Product Change Notification / NTDO-21AZXP130

CCB 6142.001 Final Notice: Qualification of MPHL as an additional final test site for ATM90E32AS-AU-Y, ATM90E32AS-AU-R and SWF2L30A-AU-R catalog part numbers (CPN) available in 48L TQFP (7x7x1.0 mm) package.

Pre and Post Change Summary

Tape and Reel – Carrier Tape

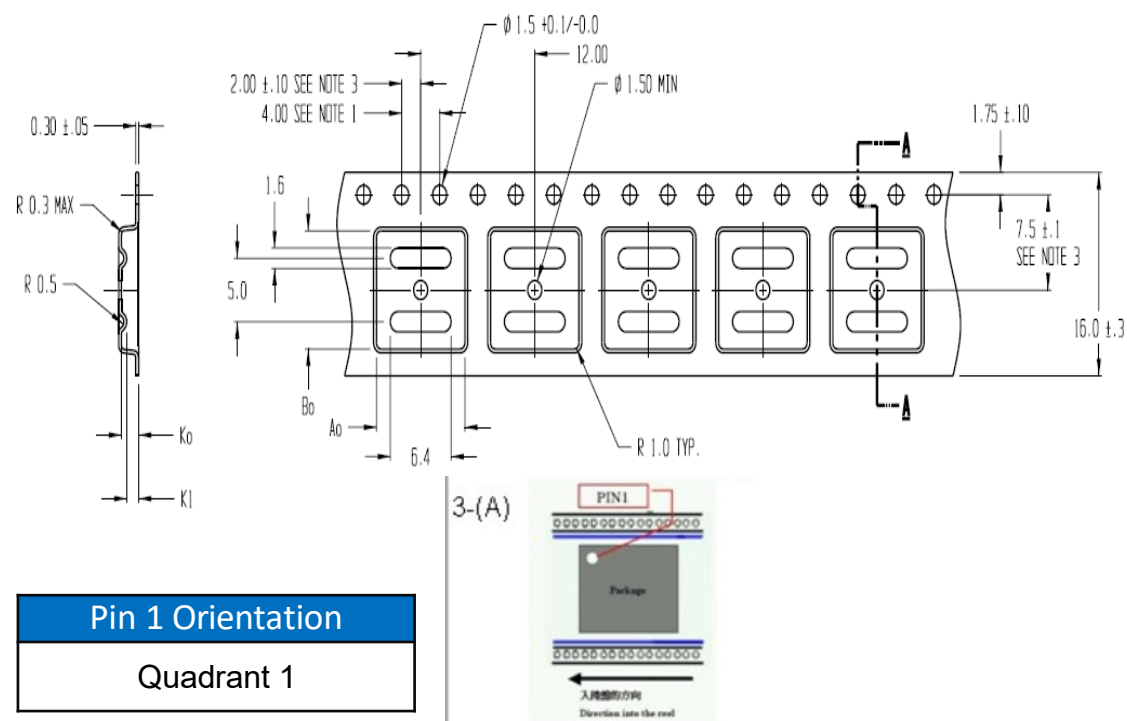
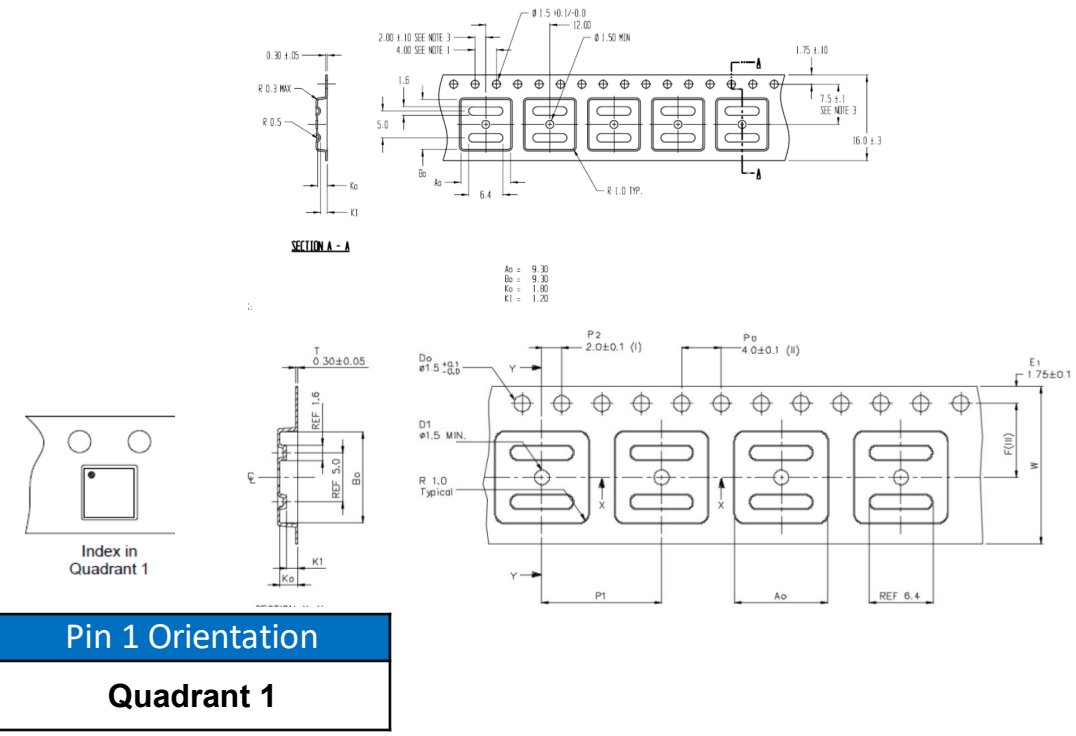
Plant	Carrier Tape Supplier	Width (mm)	Pitch (mm)	A0 (mm)	B0 (mm)	K0 (mm)	Thickness (mm)	BQM
ASE9	Supplier 1	16	12	9.3	9.3	1.8	0.3	1000
MPHL	Supplier 1	16	12	9.3	9.3	1.8	0.3	1000
MPHL	Supplier 2	16	12	9.3	9.3	1.8	0.3	1000

Tape and Reel – Cover Tape

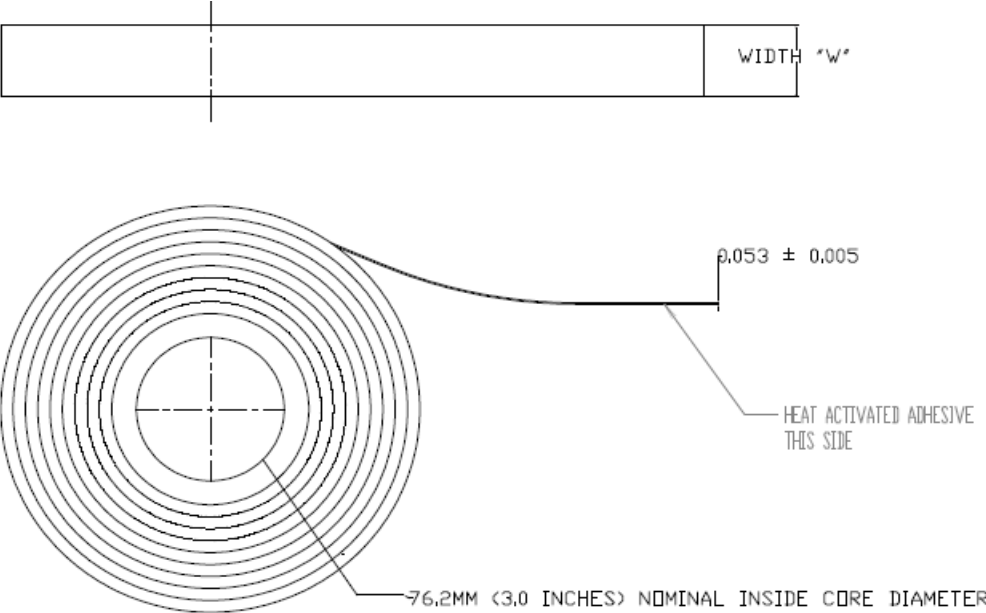
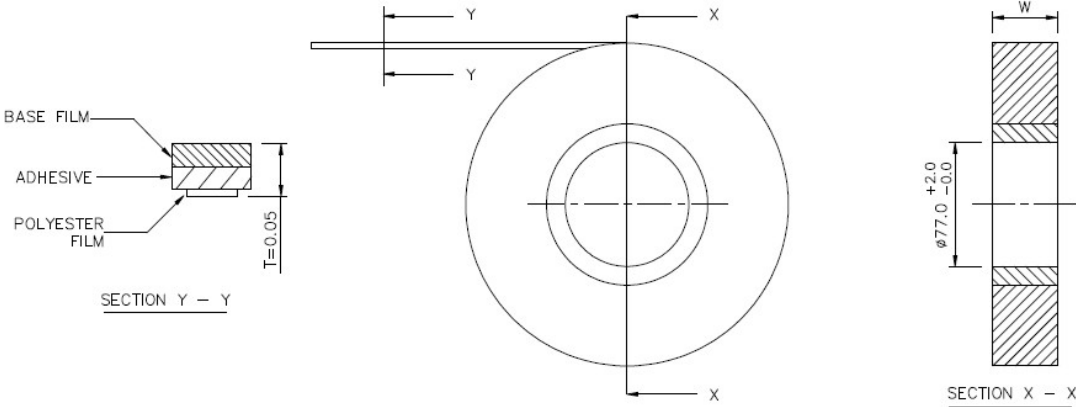
Plant	Carrier Width	Cover tape Width "W" (mm)	Thickness (mm)	Sealing Methodology
ASE9	16	13.3	0.053	Heat
MPHL	16	13.3	0.045 – 0.055	Pressure

Pin 1 Orientation

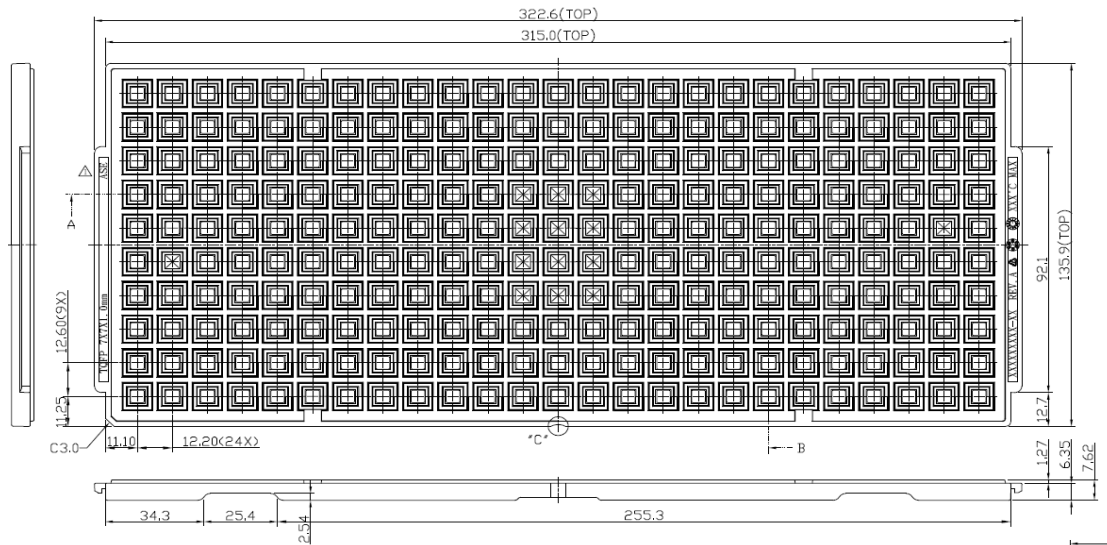
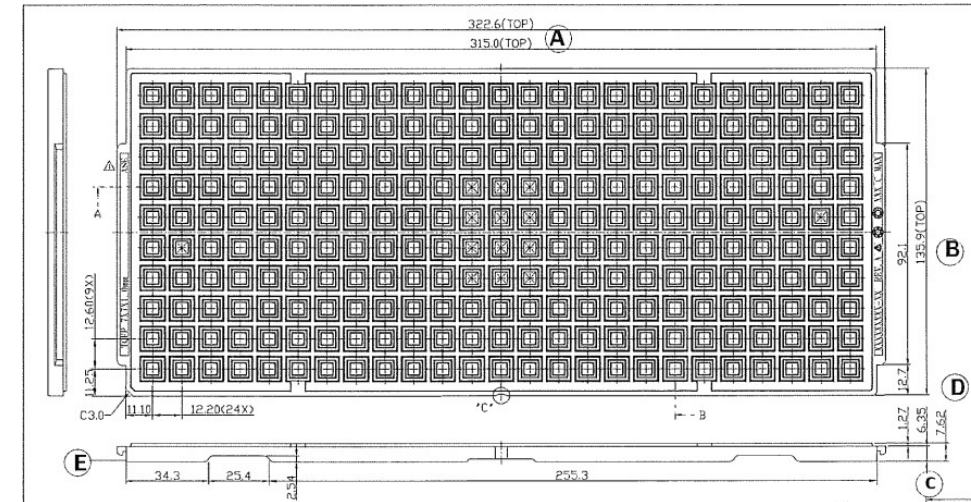
1D

Near CHAMFER SIDE

Plant	Length – max outer (mm)	Width – max outer (mm)	Thickness – max (mm)	Color	BQM
ASE9	315	135.9	7.62	BLACK	250
MPHL	315	135.9	7.62	BLACK	250
